Access Compliance Report

Public Rights-of-Way (Curb Ramps)

Intersection ID: 23730	Main Street: PROVIDENCE_RD	Cross Street: CEDAR_CROFT_DR	Location: SE
ADA ID: D10DE8AA27FE	Ramp Type: Perp	Initial Pass/Fail: Fail	Overall Compliance: No
Codes/Mitigation Info/Possible Solution		Field Measurements/Component Compliance	
Severity Score: 21.25

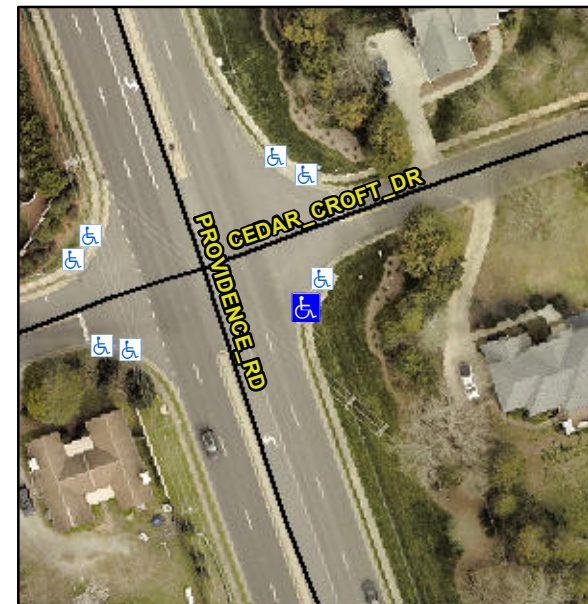
R304.5.1, R304.2.2

Compliance	Description	Data	Compliance	Description	Data
N/A	Ramp Length (in)	61.0	No	Ramp Slope (%)	9.5
No	Ramp Width (in)	47.5	Yes	Ramp XSlope (%)	1.6
N/A	Flare Type LT	N/A	N/A	Flare Type RT	N/A
N/A	Flare Slope LT (%)	N/A	N/A	Flare Slope RT (%)	N/A
N/A	Flare Traversable LT?	N/A	N/A	Flare Traversable RT?	N/A
N/A	Landing Length (in)	N/A	N/A	DWS Provided?	N/A
N/A	Landing Width (in)	N/A	N/A	DWS Contrast?	N/A
N/A	Landing Slope (%)	N/A	N/A	DWS Length (in)	N/A
N/A	Landing X Slope (%)	N/A	N/A	DWS Full Width?	N/A
N/A	Landing Curb? (Y/N)	N/A	N/A	DWS Offset (in)	N/A
N/A	Shared Landing?	N/A			
N/A	Gutter Ponding?	N/A	N/A	Gutter Slope (%)	N/A
N/A	Gutter Lip Ht (in)	N/A	N/A	Gutter X Slope (%)	N/A
N/A	Painted X Walk1?	No	N/A	Painted X Walk2?	N/A
	X Walk 1 Direction	To W		X Walk 2 Direction	N/A
N/A	X Walk 1 Width (in)	N/A	N/A	X Walk 2 Width (in)	N/A
	X Walk 1 Slope (%)	4.5		X Walk 2 Slope (%)	N/A
	X Walk 1 X Slope (%)	3.7		X Walk 2 X Slope (%)	N/A

Remove & Replace Entire Ramp.
